ADDENDUM NO. 1

TO: PLANS AND SPECIFICATIONS FOR STATE OF MISSOURI

**Renovate Lobby and Restrooms 1st and 2nd Floor
Howerton State office Building
Jefferson City, Missouri
PROJECT NO.: O2339-01**

A-201

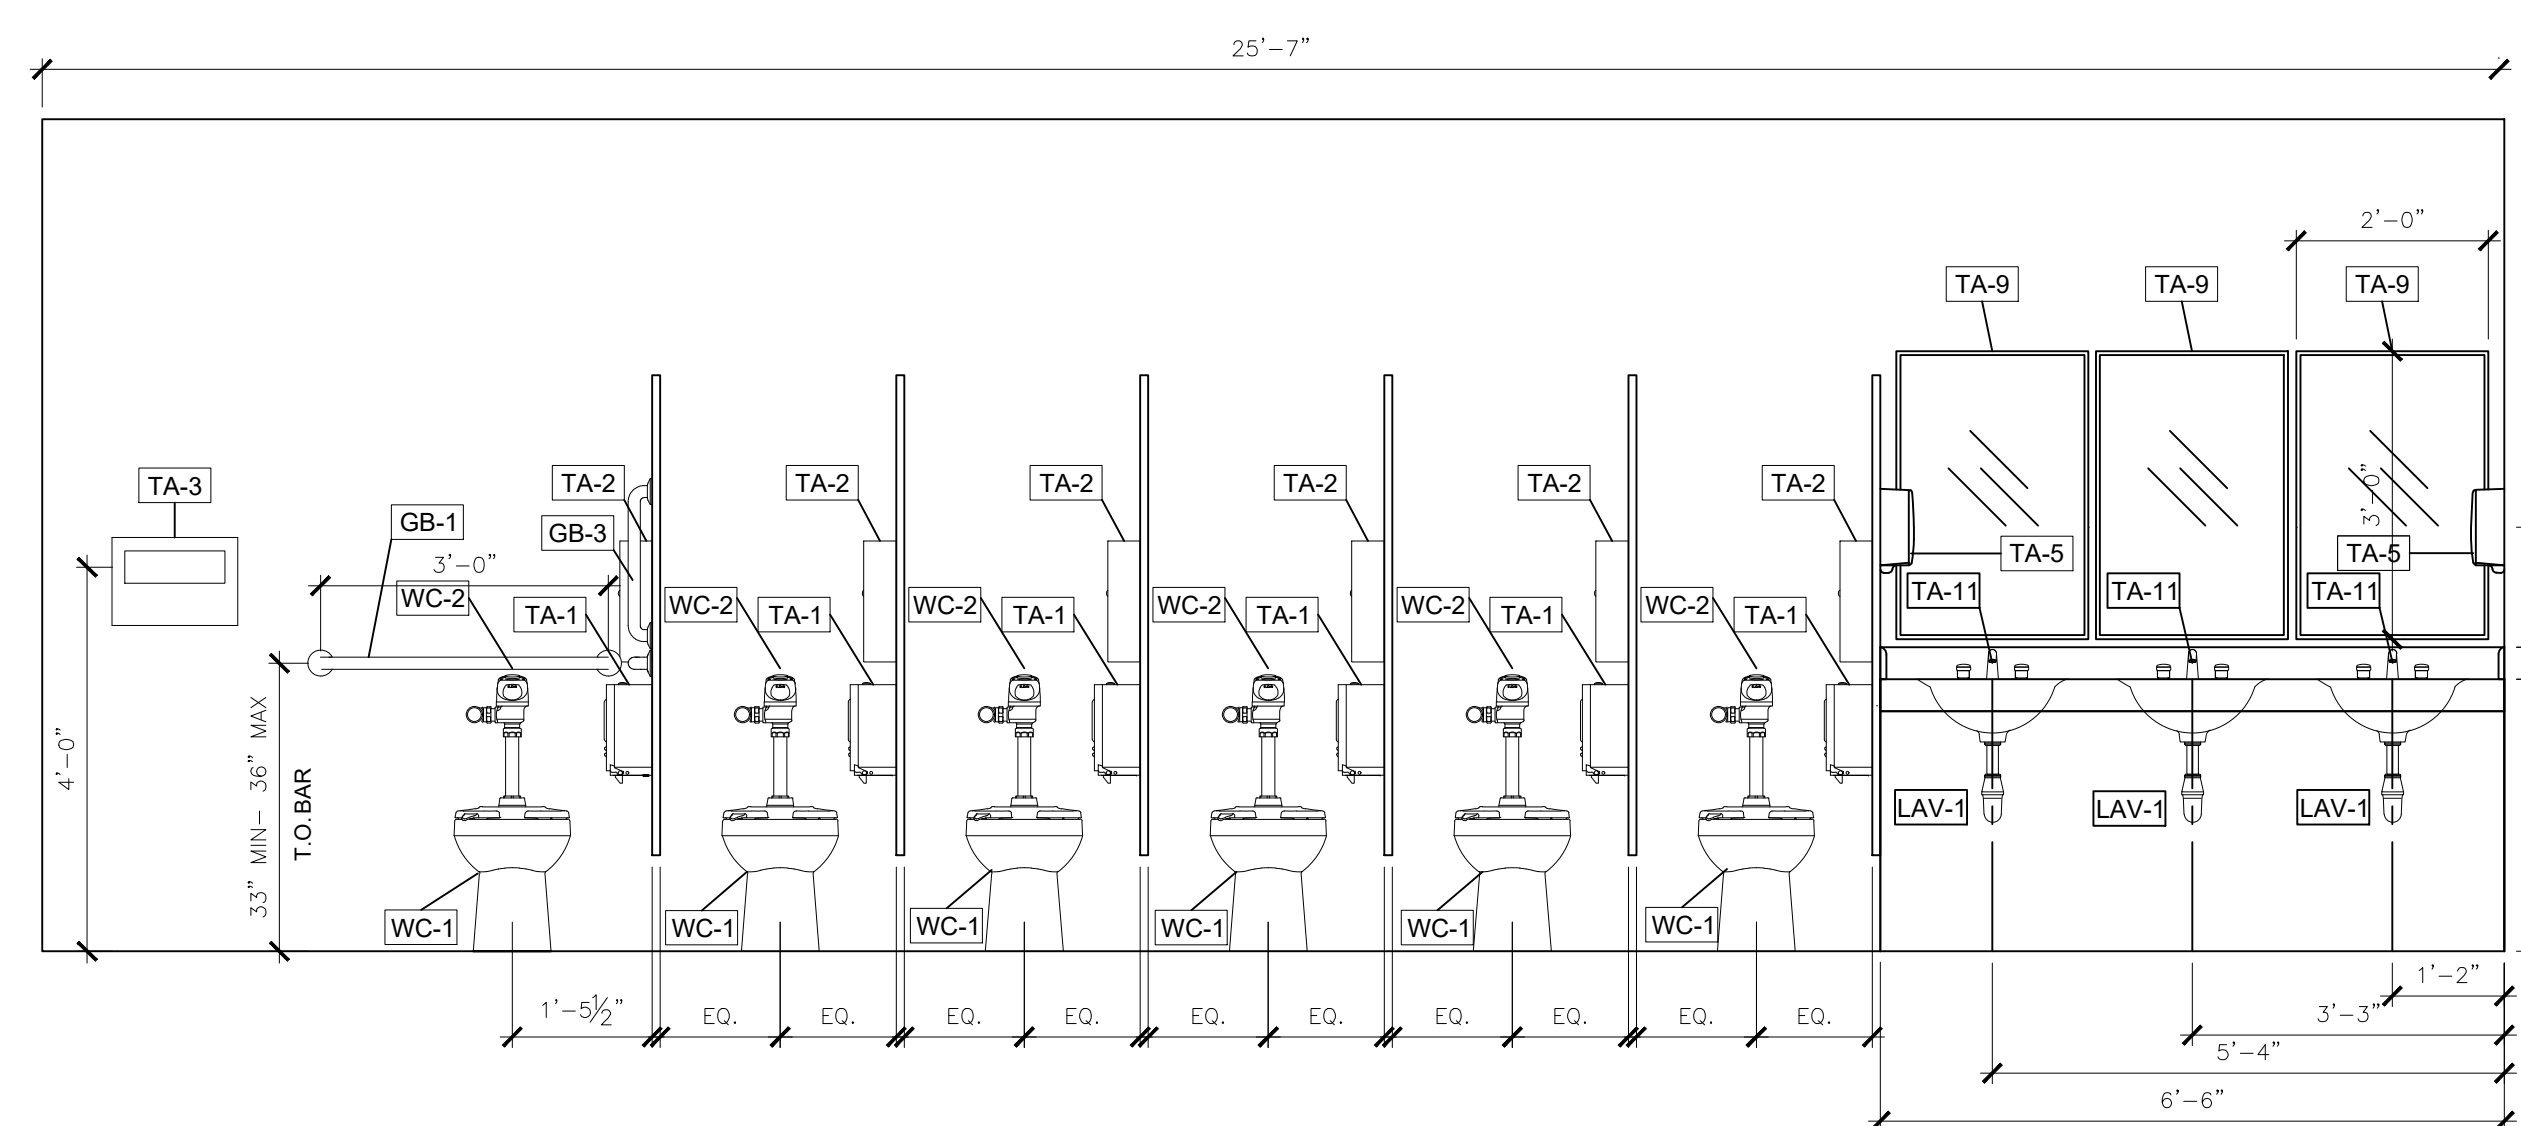
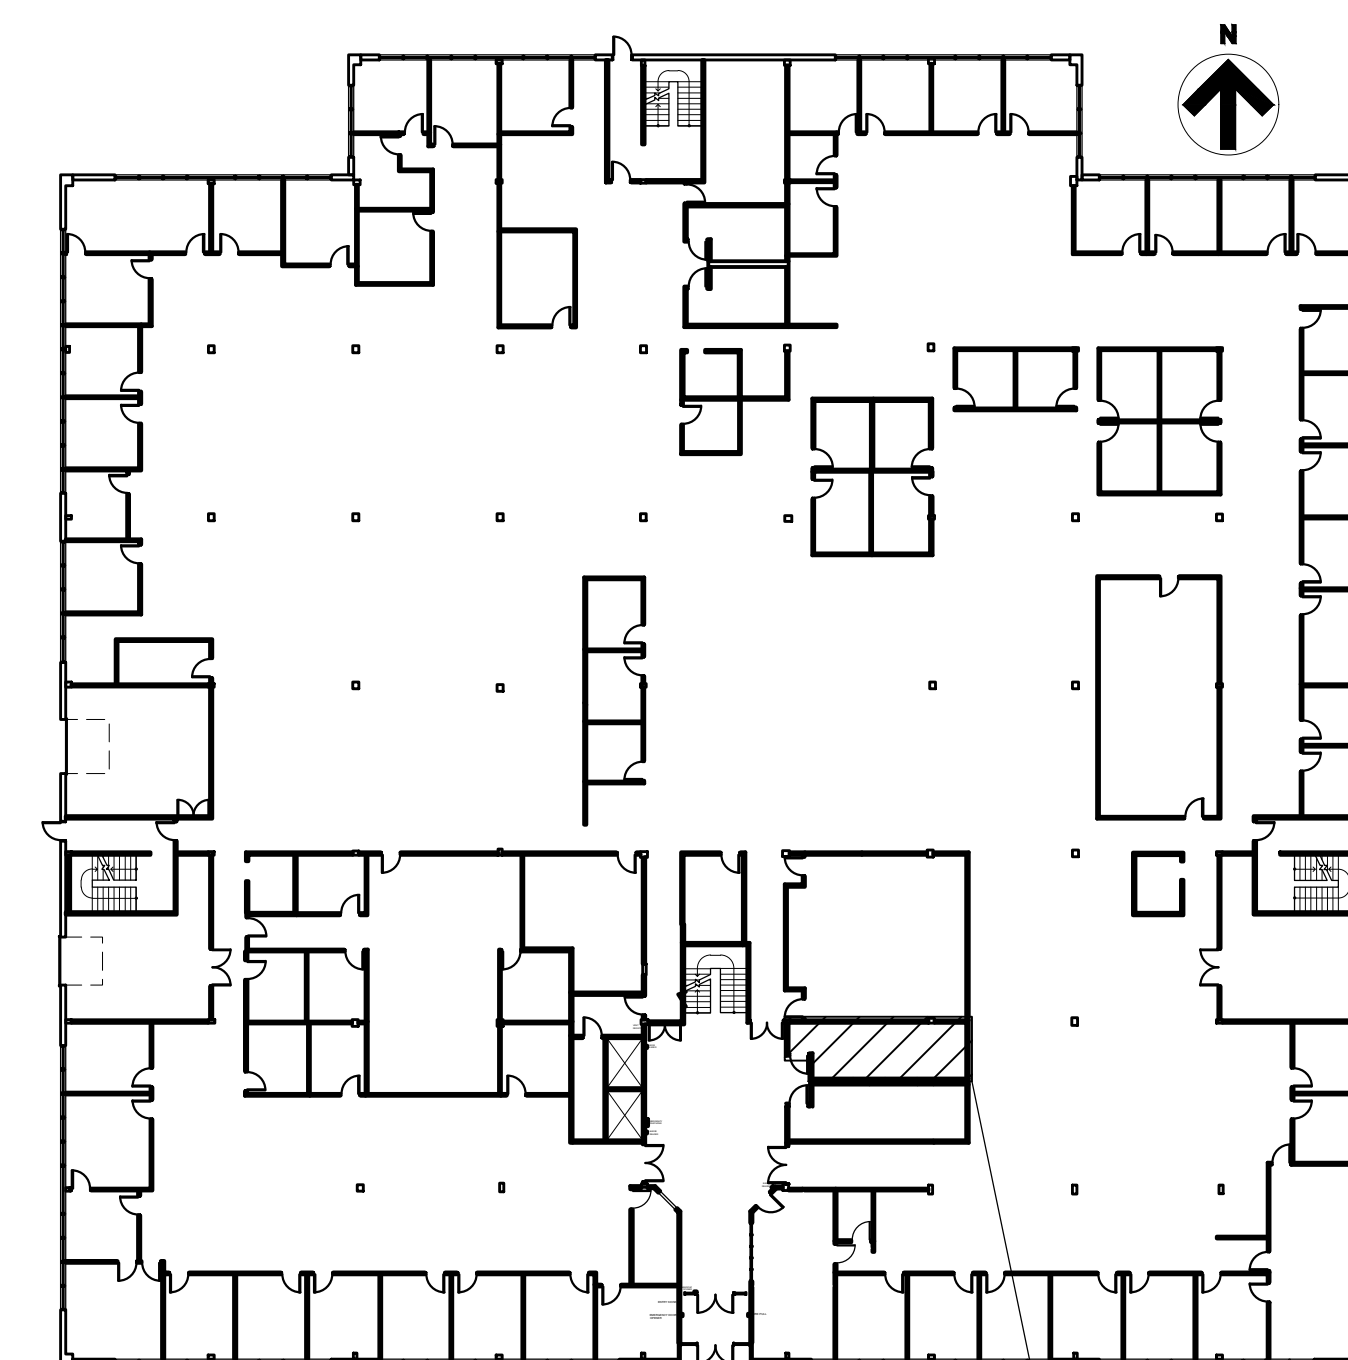
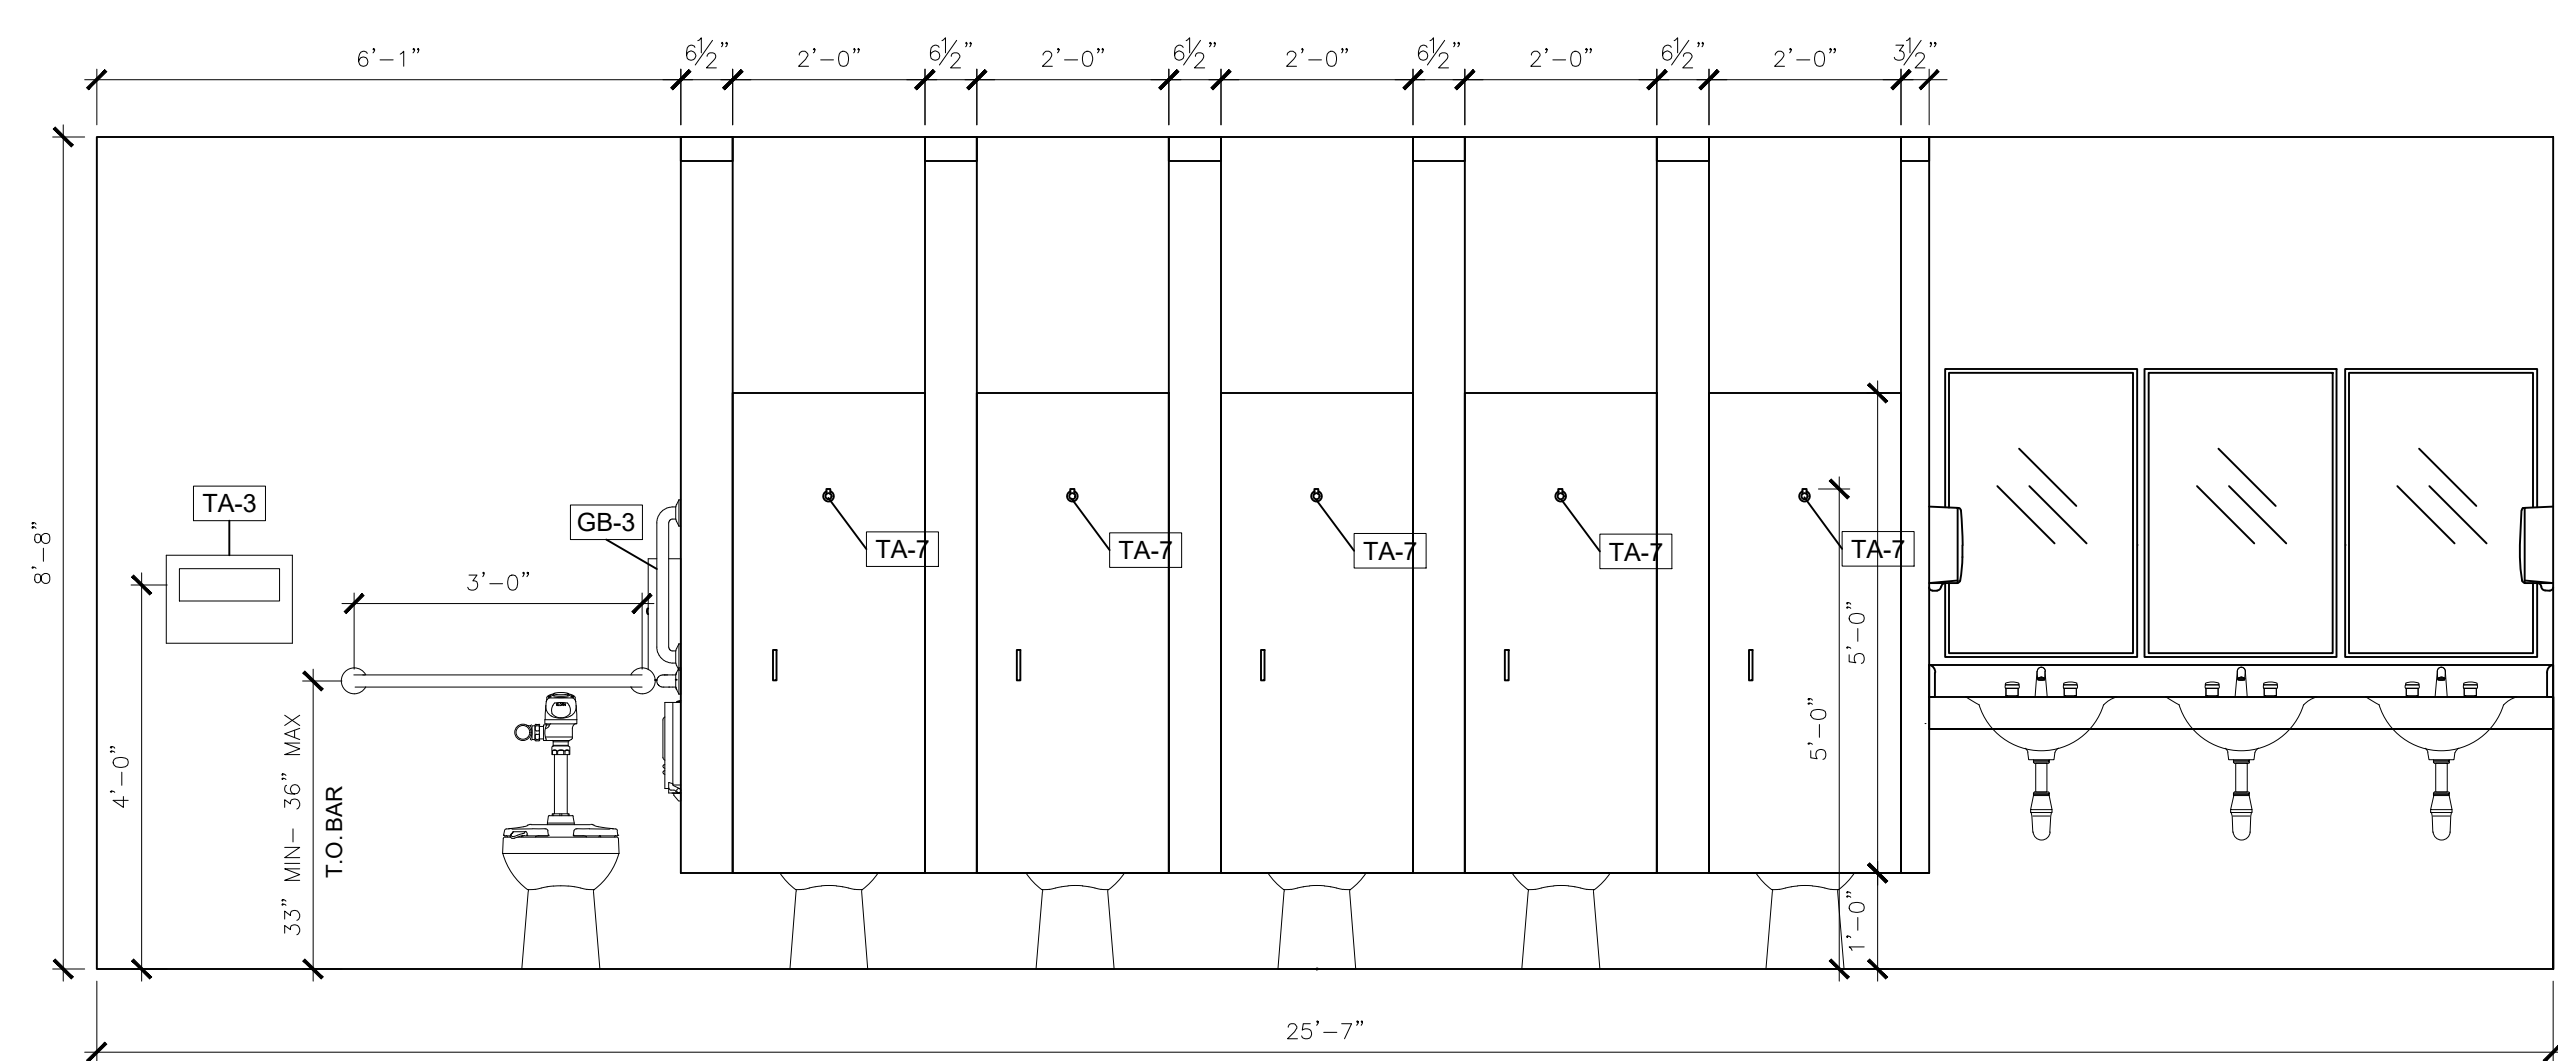
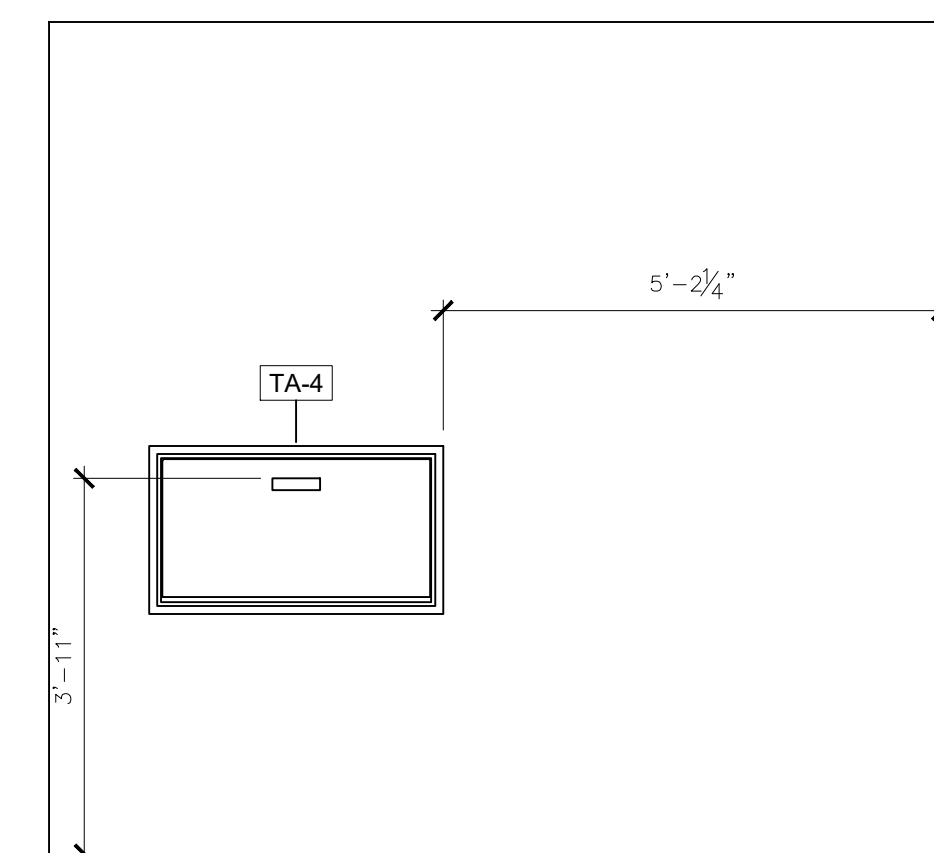
A-201

1. Restroom Finish Schedule: Clarifications per mark.
 - GB-1 Changed grab bar to 36" grab bar.
 - GB-2 Changed grab bar to 42" grab bar.
 - GB-3 Changed grab bar to 18" grab bar.
 - TA-7 Changed coat hook to coat hooks (to be installed inside of stalls)
 - TA-8 Changed mirror to 24" x 72" mirror.
 - TA-9 Changed mirror to 24" x 36" mirror.
2. Changed note from: See A-601 for full fixture schedule to See sheets A-104 - A-105 for full fixture schedules.
